**TOWN OF HERNDON, VIRGINIA
ARCHITECTURAL REVIEW BOARD
WORK SESSION AGENDA
JULY 3, 2019
HERNDON COUNCIL CHAMBERS BUILDING
765 LYNN STREET
7:30 P.M.**

Case Number & Type: ARB #19-24; Freestanding Sign
Case Summary: Construct a new monument sign near an existing vehicle entrance
Case Location: 494 Elden Street, Herndon Centre

Case Number & Type: ARB #19-28; Amendment to a Previous Approval
Case Summary: Revise/update approved design standards under a previously approved master sign plan
Case Location: 301 -315 Spring Street and 340-366 Victory Drive, Herndon – Reston Industrial Business Park

SIGN LOCATION
EXHIBIT

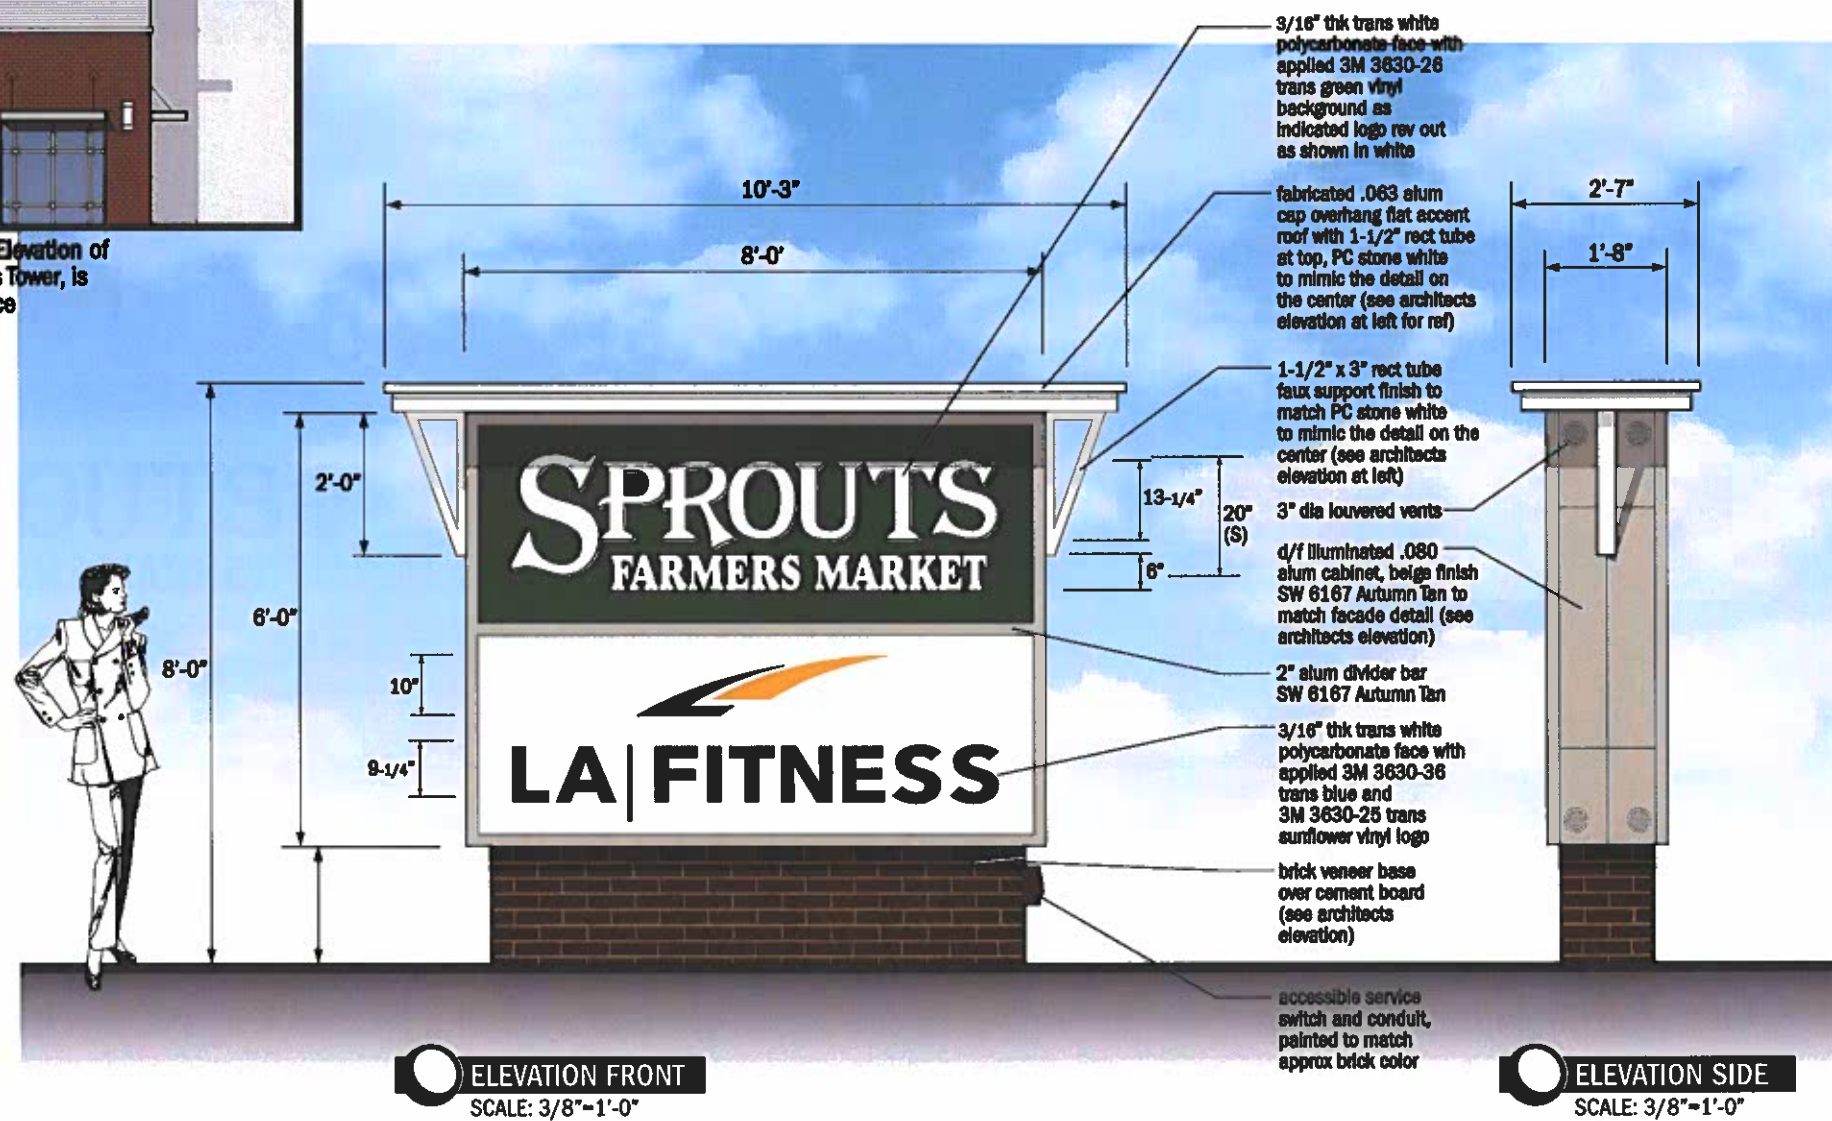
1. The application proposes a total of 48 square feet of signage to be placed on frontage along Elden Street; and places the sign in a position that will not interfere with lines of sight, approved landscape design for the site, or required easements. Section 78-141.4. - Sign standards for commercial districts, Table 141.4(a) specifies that one (1) square foot of sign area for each linear foot of frontage is authorized in the PD-B zoning district with a maximum of 50 square feet per sign. In this case, the west elevation, street facing façade and the adjacent façade visible from Elden Street well-exceed 50 linear feet, and thus the sign may have up to 50 square feet of area. The proposed signage meets the location, sign area, and overall sign dimensions of the referenced zoning ordinance section.

3. The proposed sign generally complies with the applicable design criteria within the Town's Architectural Control District as specified in Section 58-96 of the Town Code of Ordinances (Attachment #5). However, in this case, staff finds that the proposed sign base appears to be very narrow and top-heavy relative to other portions of the sign creating an awkward appearance. Staff is recommending that the Board and the applicant consider a wider and deeper brick base to more closely resemble the architecture/form of the associated building.

In addition, staff has concerns regarding the glaring brightness and stark contrast of the white background of the LA Fitness sign panel when internally lit with white LED lights at night when compared to the Sprouts Farmers Market sign panel. Staff is recommending that the Board and applicant consider reversing the lettering and background color fields such that the background is blue, and the lettering is white, similar to the lettering of the LA Fitness wall signs that will appear on the commercial building.

Motion Alternatives:	1. Motion to deny the application. 2. Motion to approve the application as submitted. 3. Motion to approve with condition(s). 4. Motion to continue public hearing to a date certain or the next ARB Public Hearing for action to address a specified design issue or concern of the Board.
Recommended Motion:	Motion for approval of ARB #19-24, in accordance with Alternative #3, with the following conditions: 1. The dimensions of the brick base shall be revised to improve the overall proportions of the base to the sign per the staff design comments;

2. The sign panel for LA Fitness shall be modified to reverse the sign color fields such that the background is blue, and the lettering is white to address staff design comments; and 3. The proposed freestanding sign shall be constructed/installed in substantial conformance with the application and supporting materials as submitted June 10, 2019, June 21, 2019, and any subsequent updates required by the Board to meet Conditions #1 and #2, as noted.
--	--

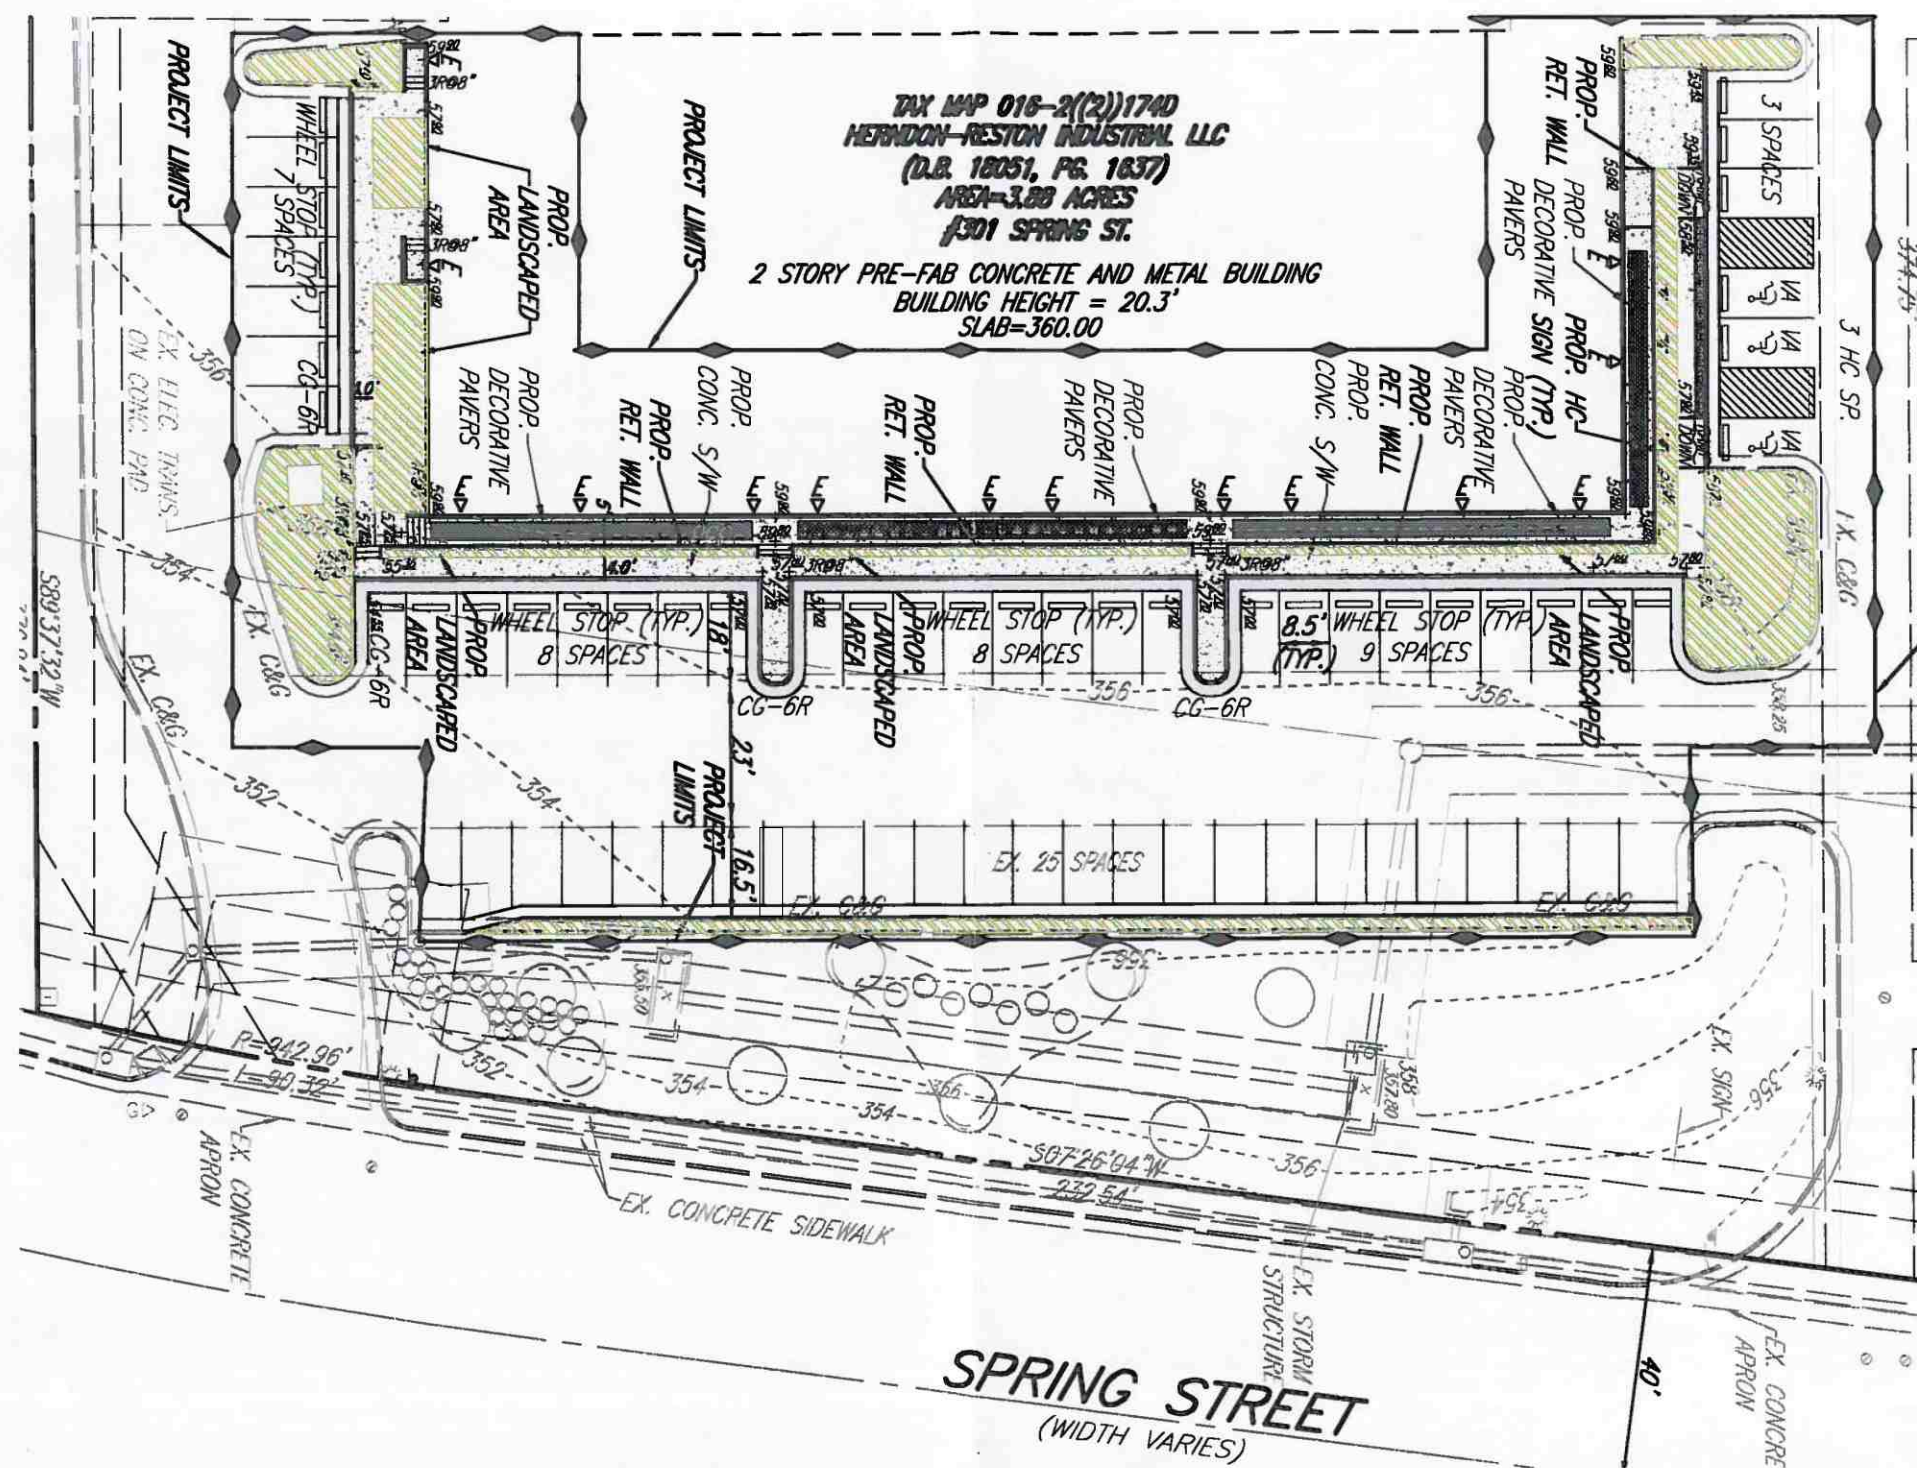
In this case, staff has determined that the proposed modifications and limited scope of design standards are not comprehensive in nature and do little to coordinate a unified design theme to achieve the intent of master sign plans as noted in the Town's Zoning Ordinance. In this case, the submission does very little to regulate sign design at the subject property and building, does not provide the staff with applicable standards and appears to be purposefully thwarting the intent of both ARB sign review and Master Sign Plans.
